ORIEL WIND FARM PROJECT

Environmental Impact Assessment Report – Addendum
Chapter 27 Addendum: Seascape, Landscape and Visual Amenity

MDR1520C
EIAR – Chapter 27 Addendum
A1 C01
December 2025

Figure 27A-1: Seascapes Character Area (SCA) 16 – North Eastern Irish Sea Islands and Beaches.

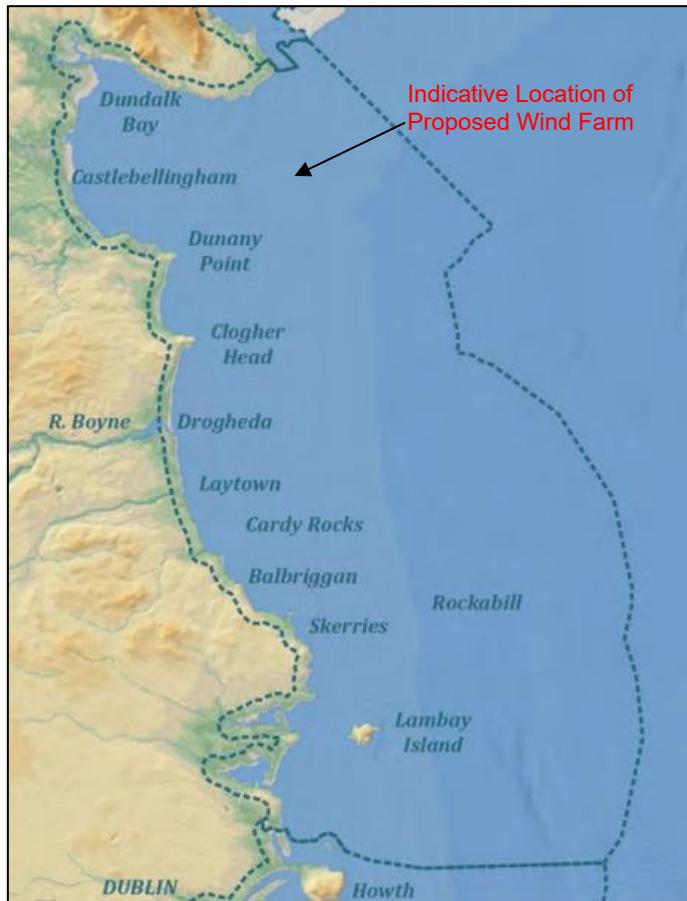
The following assessment provides a response to RFI 12.C on the potential impact on the area's sense of place and cultural identity on local communities having regard to the Regional Seascape Character Assessment for Ireland 2020 and to observers' submissions.

The proposed offshore wind turbines and substation are located within *Seascape Character Area (SCA) 16 – North Eastern Irish Sea Islands and Beaches* as defined in the *Regional Seascape Character Assessment for Ireland 2020* (herein referred to 'the Character Assessment') (Figure 27A-1). This SCA largely aligns with Large Area shown on Figure 27.7 in appendix 27-1: Seascape, Landscape and Visual Amenity Accompanying graphics (EIAR volume 2C).

The Character Assessment does not directly address whether the construction of offshore wind turbines may impact on peoples' sense of place or whether such impacts, if they were to arise, might be positive or negative. However, the Character Assessment does note in regard to SCA 13 - South East Irish Sea that offshore turbines (Arklow Bank 1, constructed in 2003 / 2004) can provide “*visual reference points*”. It is reasonable to consider that the proposed offshore turbines can, in a similar fashion, provide visual reference points within the Irish Sea, to the east of Dundalk Bay, thereby contributing positively to a sense of place.
